24 September 2019

TRACEWAY PARK SOFTBALL CONCESSION STAND
200 Soccer Row
Clinton, MS 39056

ADDENDUM NO. 02

SHEET A401 "DETAILS"

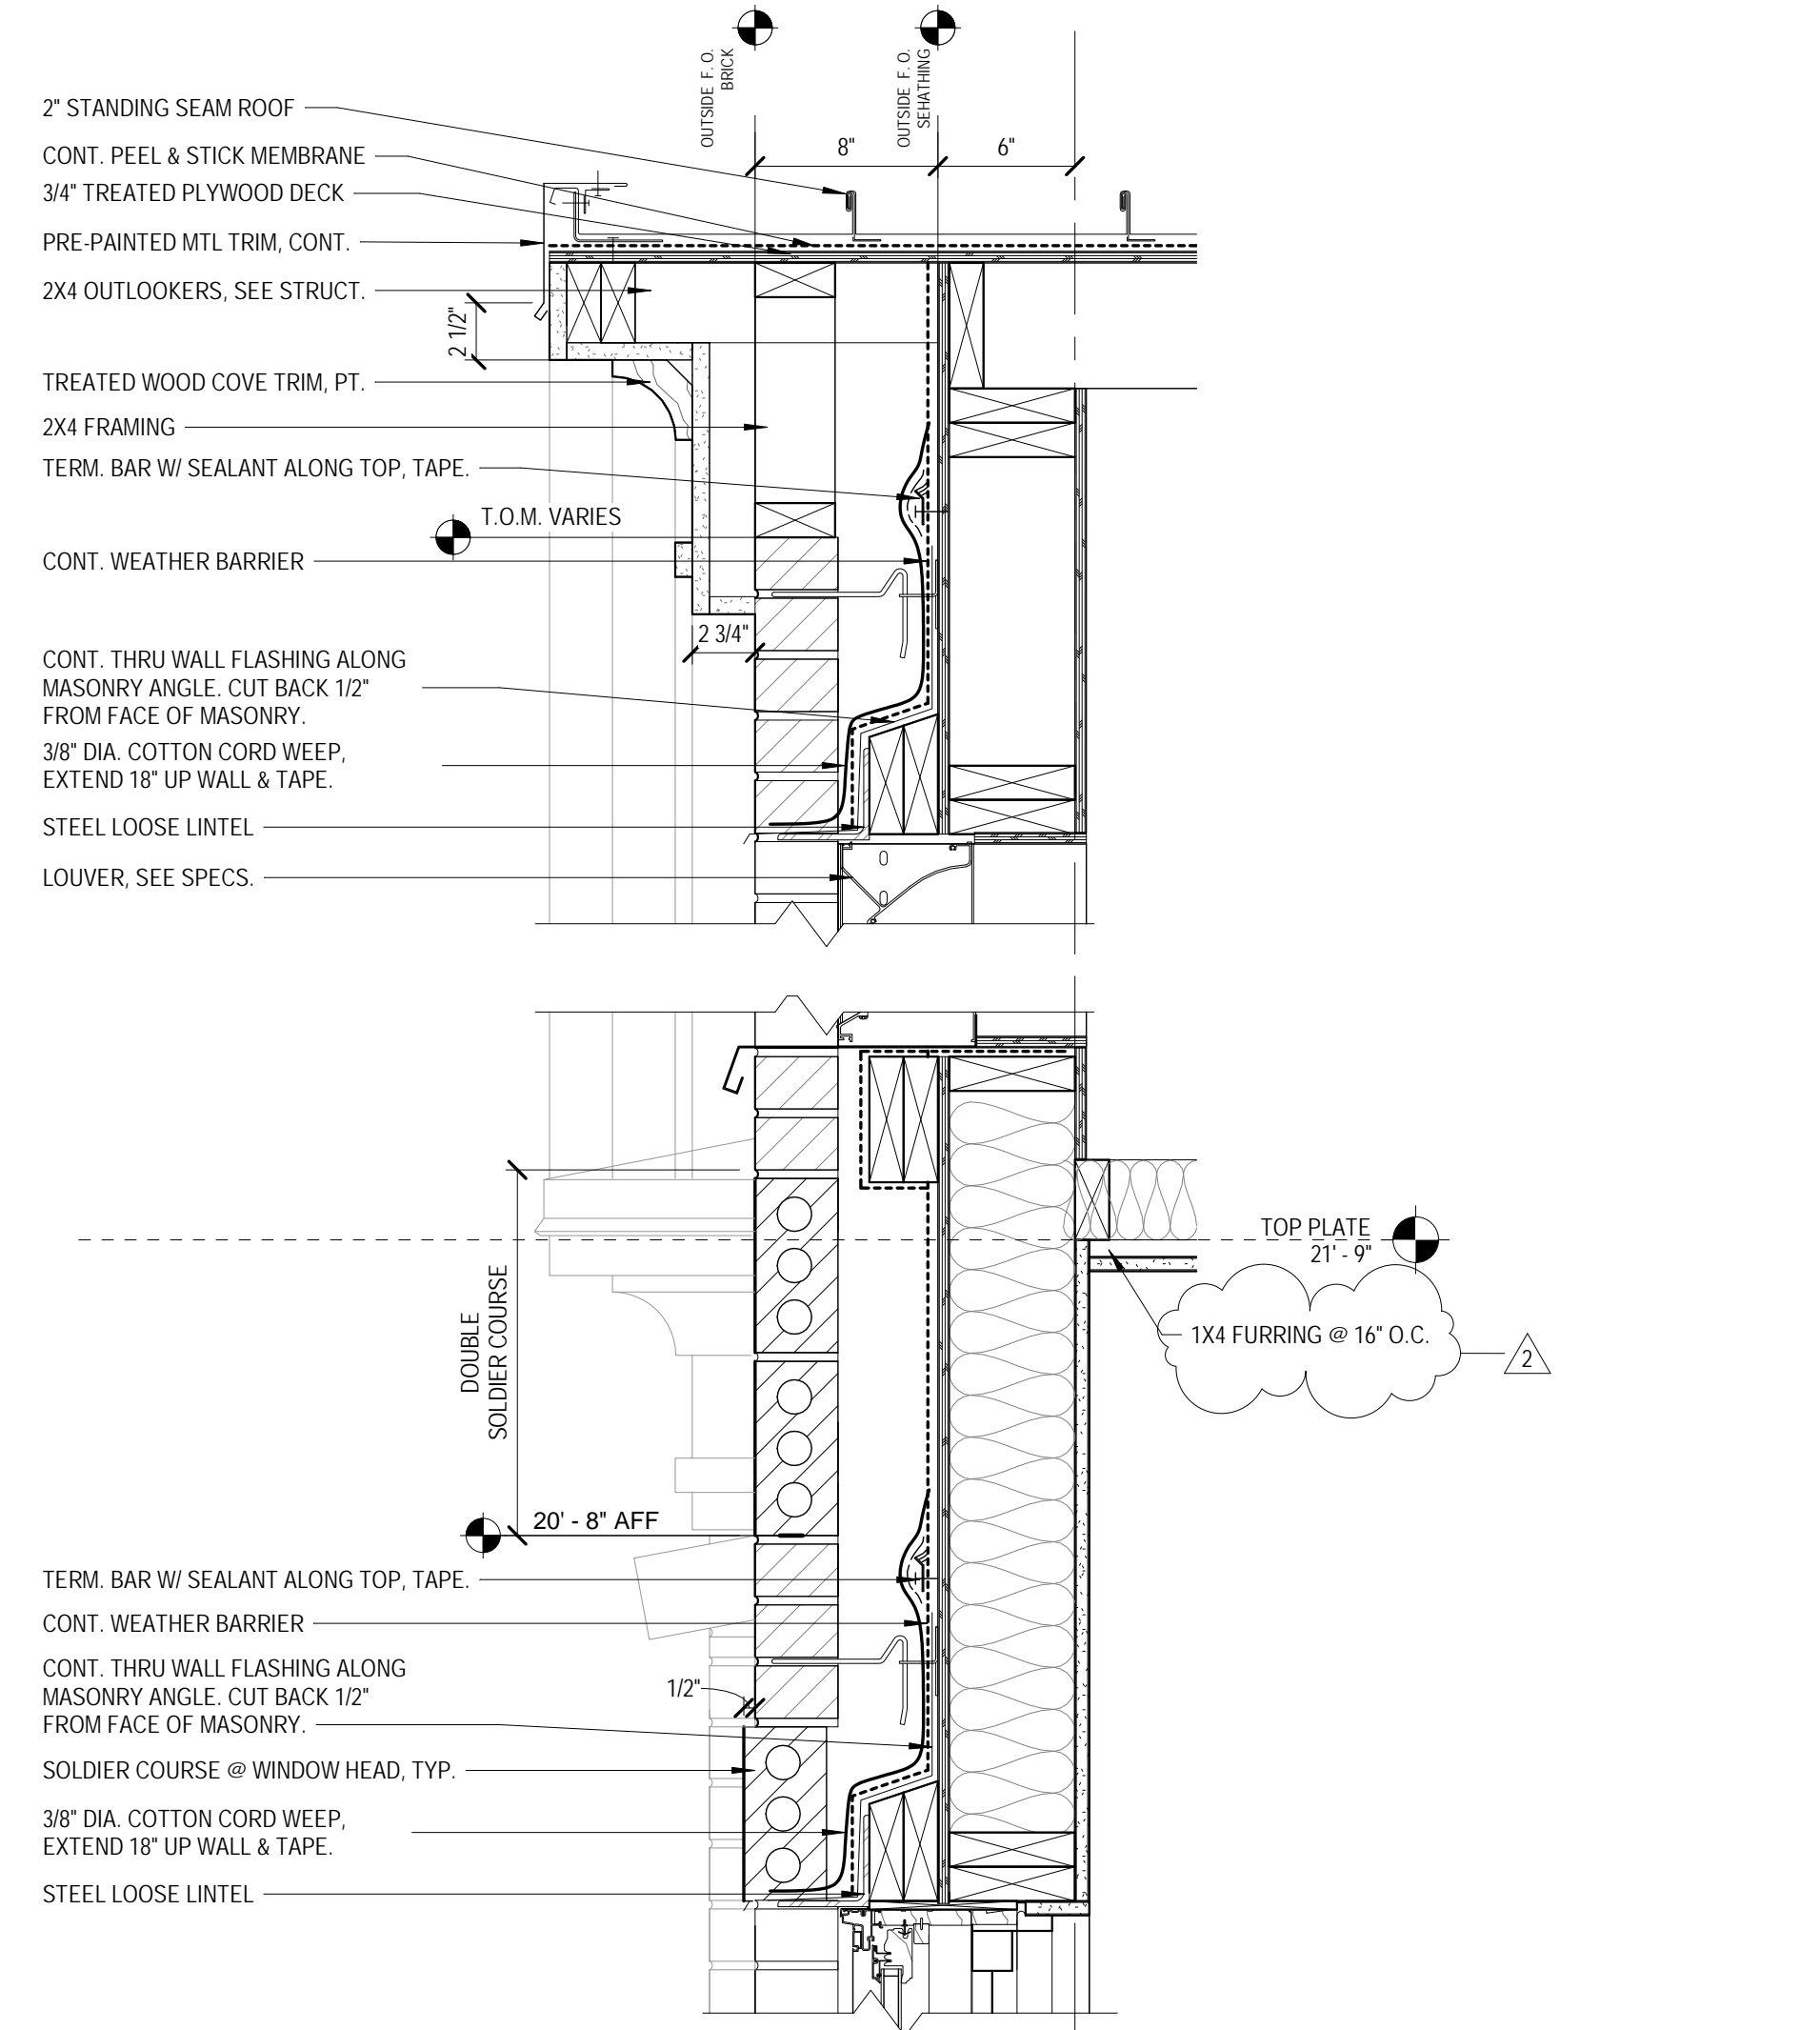
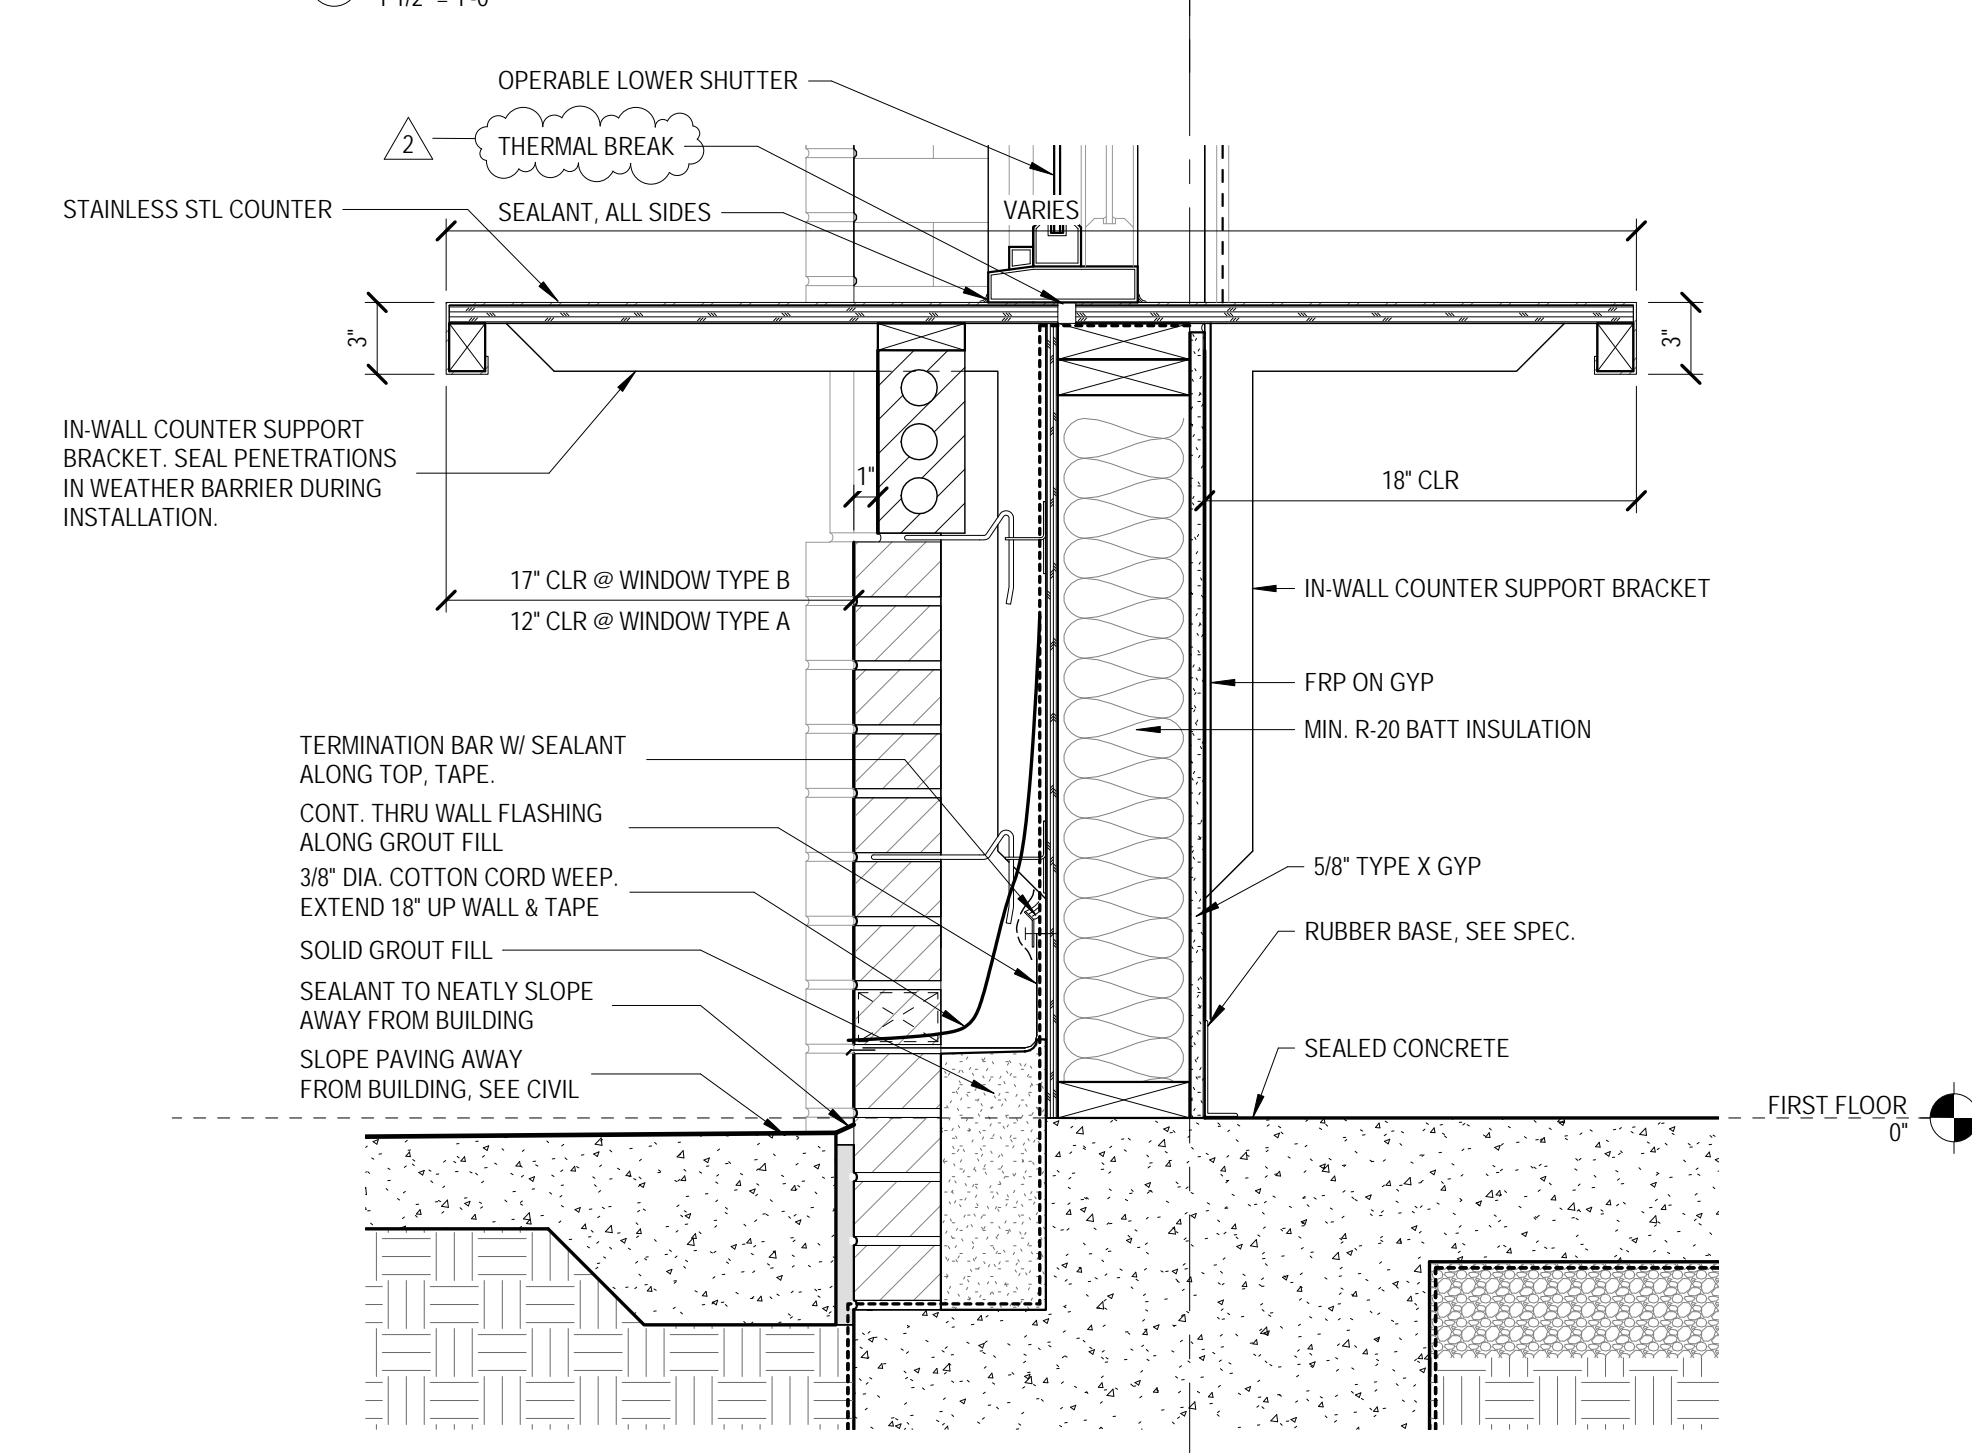
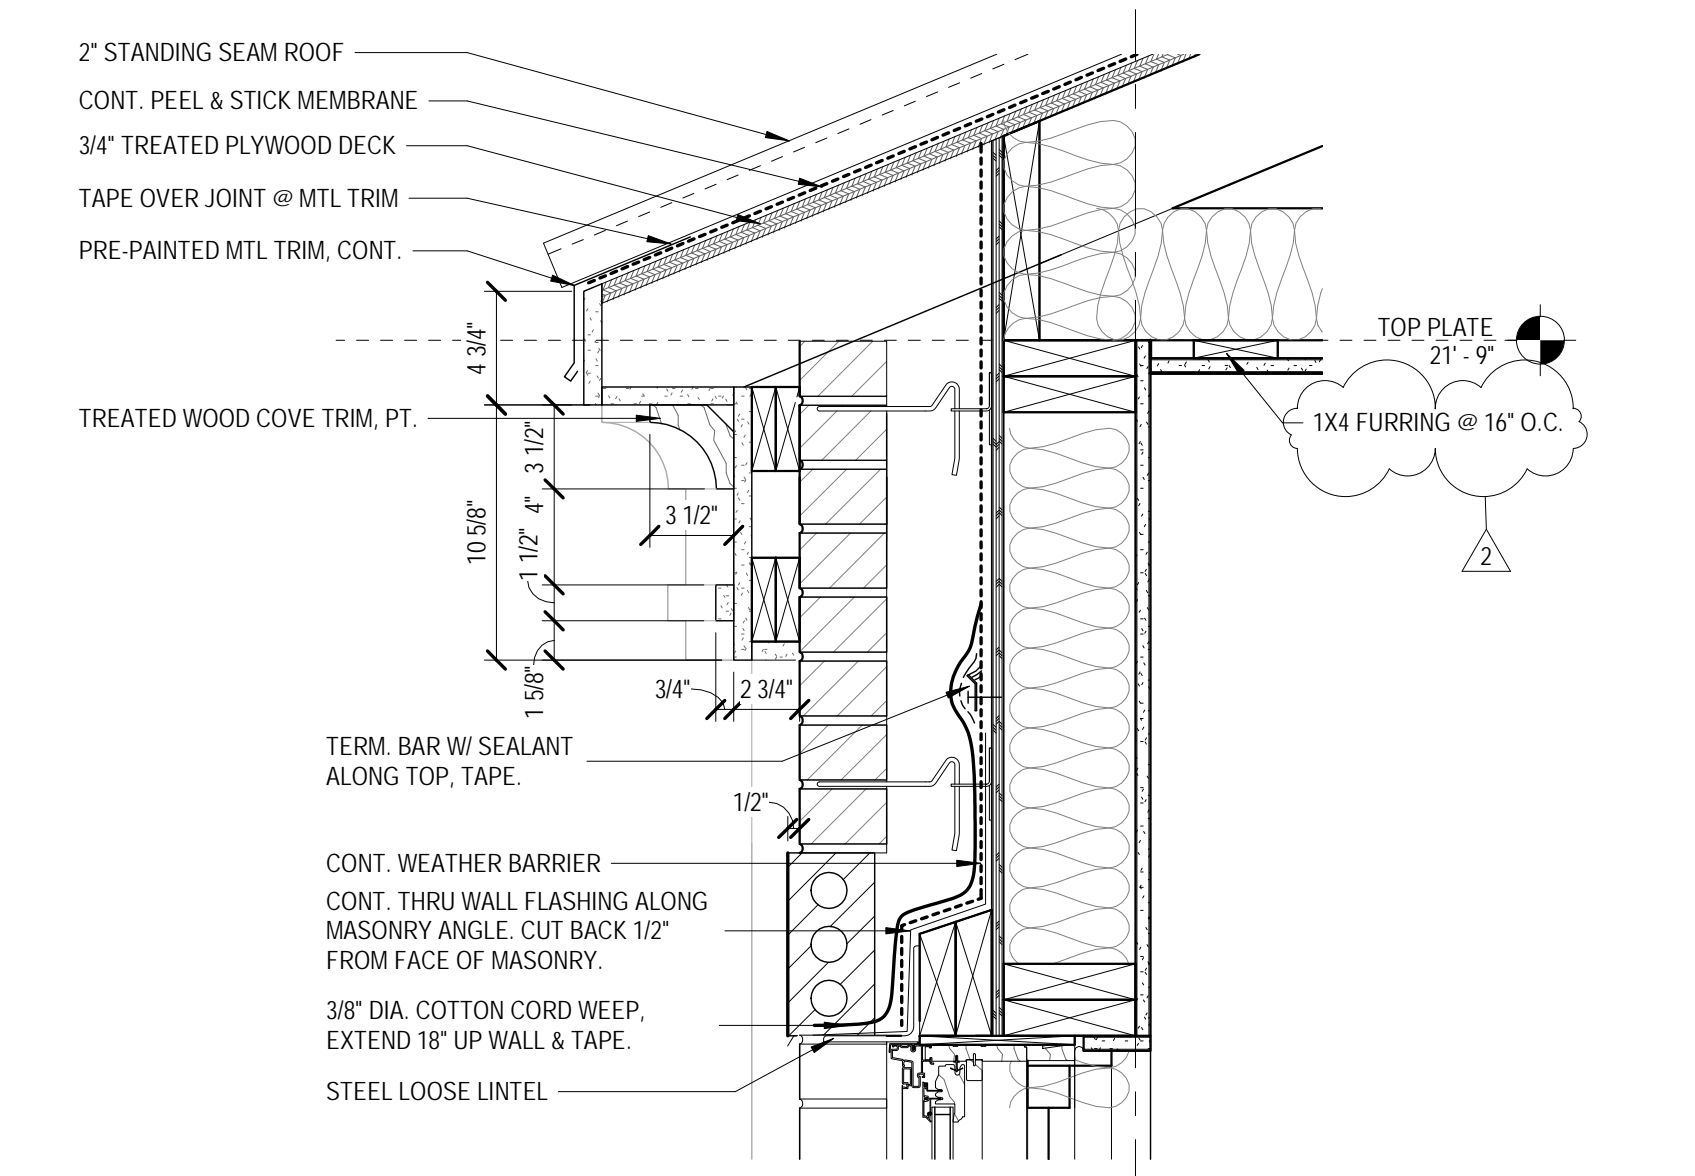
ADD note referencing the overhead coiling shutter doors at each concession window.

ADD note referencing the 1x4 furring boards at 16" on center added to the ceiling structure to support the gyp board at all ceilings.

ADD note referencing treated 1x4 furring boards at 12" on center in the porch area to support the cementitious fiber board soffit panels.

ADD note revising the beadboard cementitious fiber soffit panels in porch area to be ¼" thick.

ADD note referencing the added thermal break cut into the stainless steel counter.
